The Narragansett Electric Company d/b/a National Grid

Electric Infrastructure, Safety, and Reliability Plan FY 2024 Proposal

Responses to Division's Data Requests

RE: National Grid's Proposed FY 2022 Electric Infrastructure, Safety, and Reliability Plan Responses to Division Data Requests – Set 1

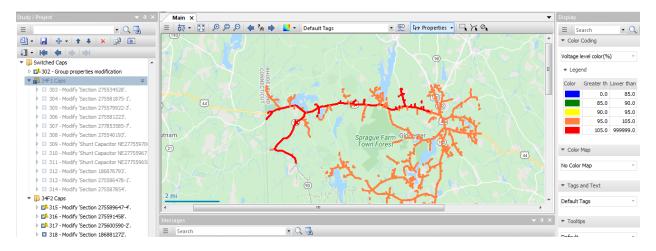
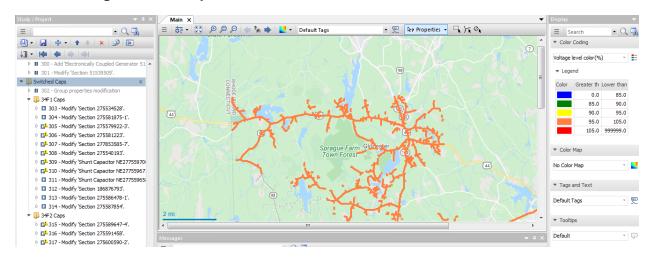
<u>CASE 1:</u> Low load day (Winter) during expected high solar DER production hours. 34F2 feeder in current configuration with currently connected and proposed DER (large and small scale).

The voltage profile above depicts the 34F2 feeder in its current state, including existing and proposed large and small scale DER facilities. The voltage stability worsens the further away from the substation due to the increased levels of DER interconnected to the Chopmist Substation.

<u>CASE 2</u>: Low load day (Winter) during expected high solar DER production. 34F2 feeder in current configuration with currently connected and proposed DER (large and small scale) with only installing advanced capacitor controls on the 34F2 Feeder.

Replacing existing capacitors with advanced switched capacitors on the 34F2 slightly improves the voltage profile but does not solve all issues.

<u>CASE 3</u>: Low load day (Winter) during expected high solar DER production. 34F2 feeder in current configuration with currently connected and proposed DER (large and small scale) with installing advanced capacitor controls on both the 34F1 and 34F2 Feeder.

Replacing all existing capacitors with advanced switched capacitors on both the 34F1 and 34F2 improves the voltage profile and brings voltages within an acceptable range.

2J2 Feeder:

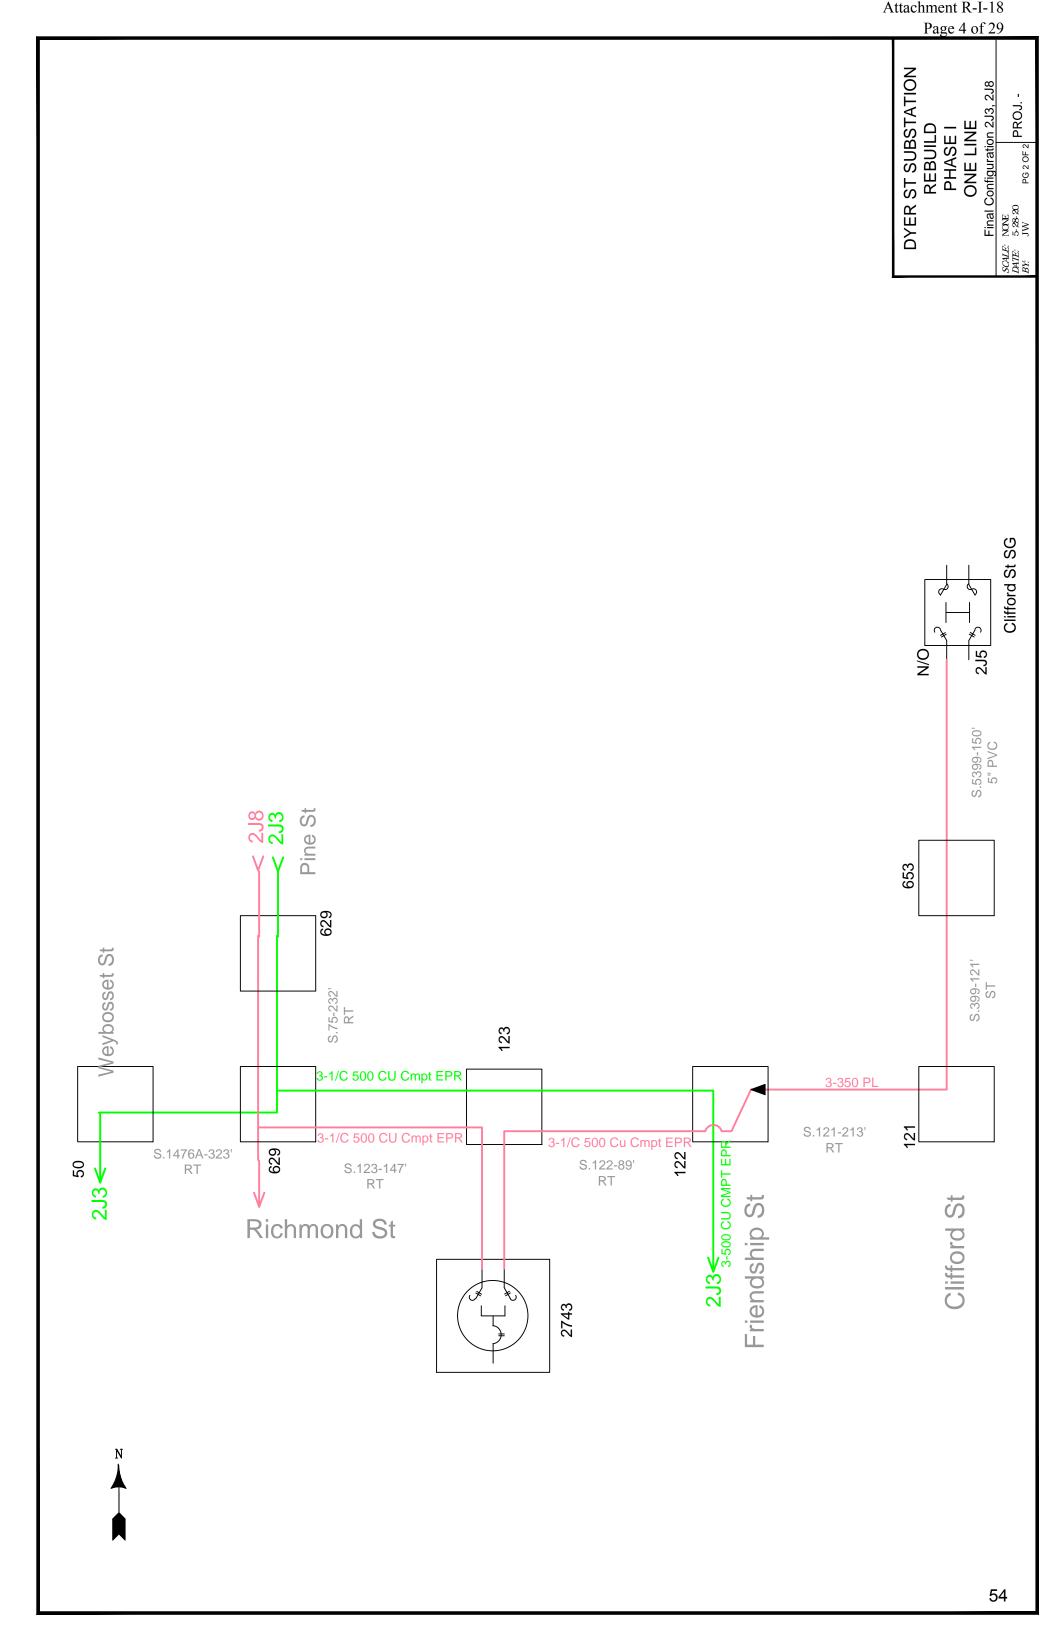
Provide a detailed scope, design and budget estimate for the revised Dyer Street project. Compare/contrast any expected changes in reliability between the previous and revised design.

- Remove all 2J2 mainline cable from Dyer St Substation to MH122 Richmond St
 - Dyer St 2J2-3 Disconnects to MH85D Dyer St Substation
 - MH85D Dyer St Substation to MH9D Dyer St
 - MH9D Dyer St to MH9A Dyer St
 - MH9A Dyer St to MH351 Peck St
 - MH351 Peck St to MH427 Friendship St
 - MH427 Friendship St to MH428 Friendship St
 - MH428 Friendship St to MH429 Friendship St
 - MH429 Friendship St to MH430 Friendship St
 - MH430 Friendship St to MH431 Friendship St
 - MH431 Friendship St to MH432 Friendship St
 - MH432 Friendship St to MH654 Friendship St
 - MH654 Friendship St to MH122 Richmond St, both sets
 - MH122 Richmond St to MH123 Richmond St
 - MH123 Richmond St to MH2743 Richmond St

Asset Condition Report - Dyer Street Station

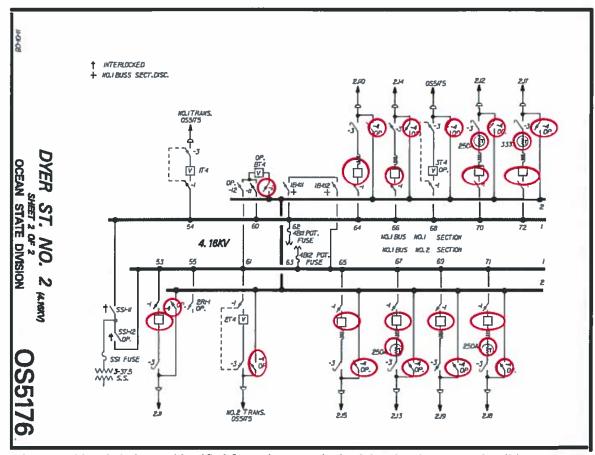
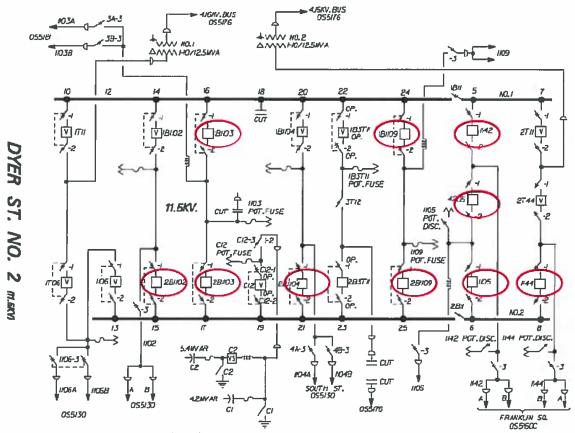
Provide the most recent project sanctioning paper for Dyer Street. Since the capacity and new substation facilities are now proposed for the South Street substation site, will the substation project name be changed?

Equipment with red circle was identified for replacement in the O&M Services Asset Condition Report

CYME Base (Existing) Case – 2030 Loading

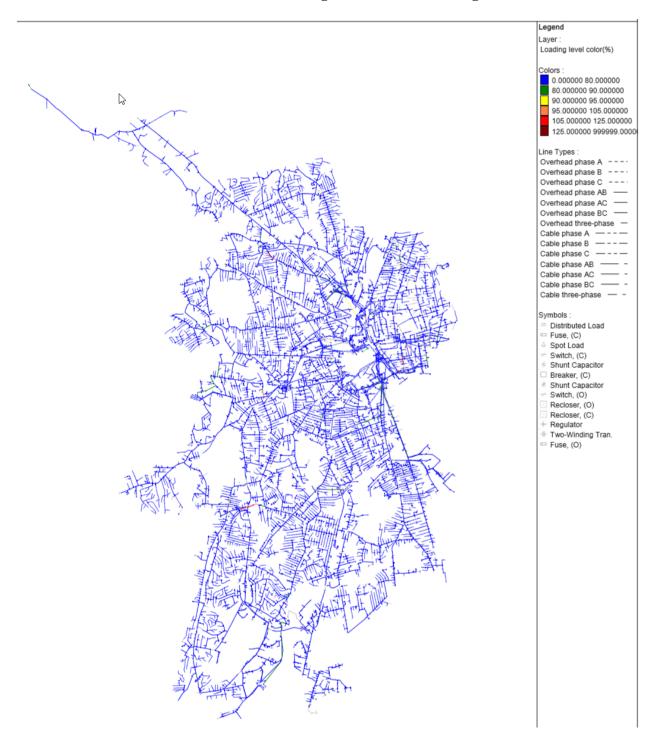
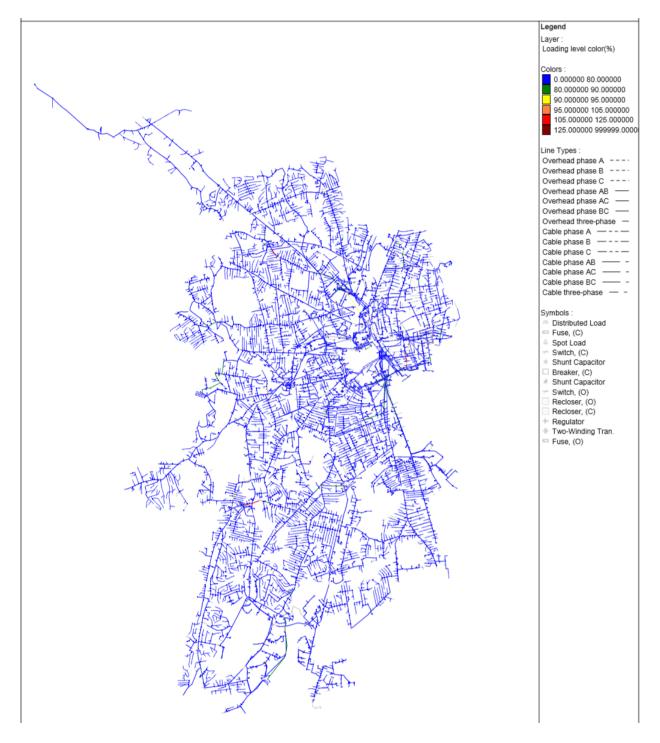
- a) Compare the load growth forecasts used at the time the study was performed to the most current forecasts.
- b) Provide an updated Table 5 Feeder Loads for Year 2030 >= 90% (no new facilities). Also provide projected feeder loads for the year 2035.
- c) Provide an updated Table 6 Calculated MWH Load-at-Risk Existing Configuration.
- d) Provide Figure 9.4.1 CYME Base (Existing) Case 2030 Loading using the Company's most recent load growth assumptions. Also provide the CYME model with projected loads in 2035.

d) Updated Figure 9.4.1 – CYME Base (Existing) Case – 2030 Loading is included below along with a figure with projected loads in 2034.

The latest forecast report is the 2020 Electric Peak Forecast which only includes forecast information through 2034. The 2021 Electric Peak Forecast report was recently finalized but the 2021 annual planning process is not complete. Until the 2021 annual planning process is complete, the current forecasts from the 2020 Electric Peak Forecast report are used as the most recent, which only includes forecasts out to 2034. Therefore, this response only includes load information for 2034, not 2035.

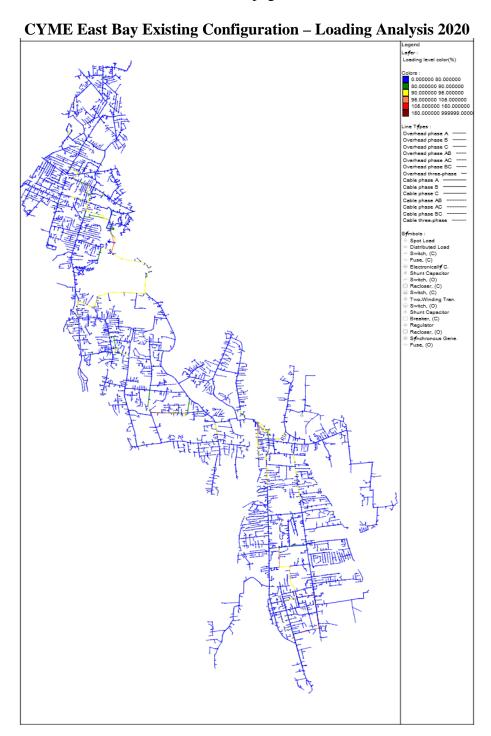
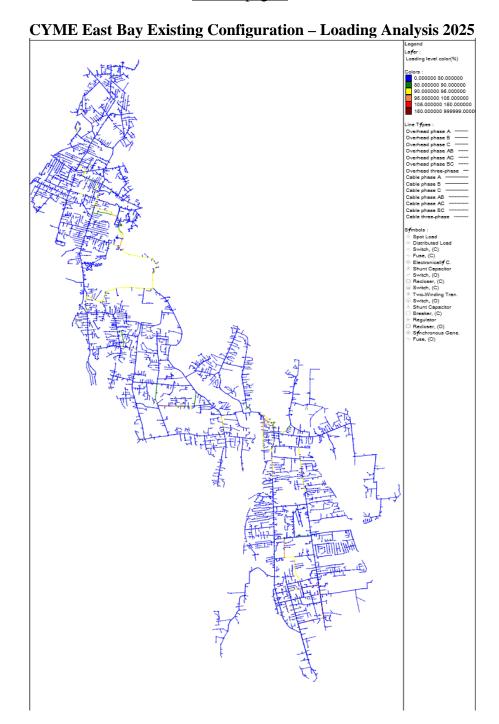
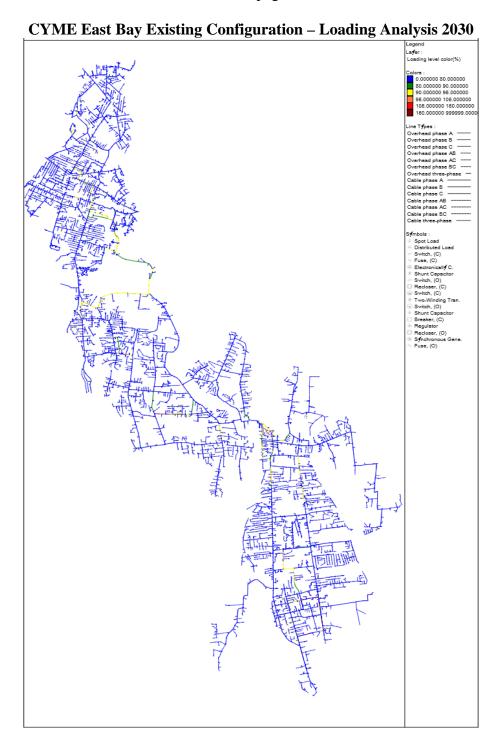
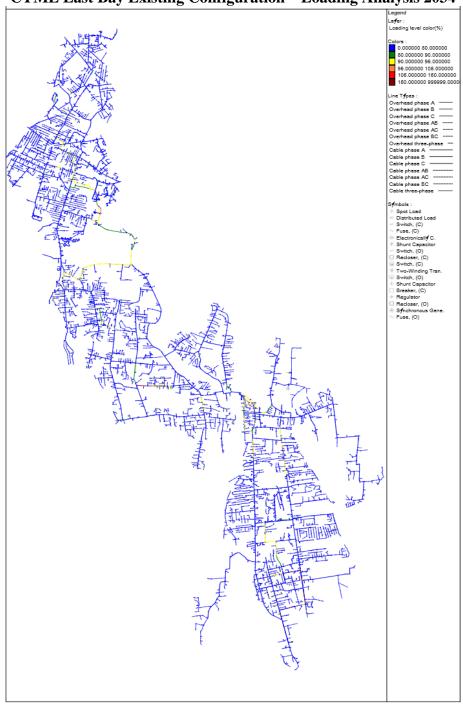
- a) Compare the load growth forecasts used at the time the study was performed to the most current forecasts.
- b) Provide an updated Table 4.1.1 Projected Summer Normal Feeder Loading utilizing current and projected feeder loadings.
- c) Provide an updated Table 4.1.2 Calculated MWH exposure and un-Served Load on Feeders.
- d) Provide Figure 9.4.2 CYME East Bay Existing Configuration Loading Analysis using current loads. Also provide the CYME model using the Company's most recent load growth assumptions for 2025, 2030 and 2035.

d) Updated Figure 9.4.2 – CYME East Bay Existing Configuration – Loading Analysis is included below along with the Company's most recent load growth assumptions for 2025, 2030 and 2034.

The latest forecast report is the 2020 Electric Peak Forecast which only includes forecast information through 2034. The 2021 Electric Peak Forecast report was recently finalized but the 2021 annual planning process is not complete. Until the 2021 annual planning process is complete, the current forecasts from the 2020 Electric Peak Forecast report are used as the most recent, which only includes forecasts out to 2034. Therefore, this response only includes load information for 2034, not 2035.
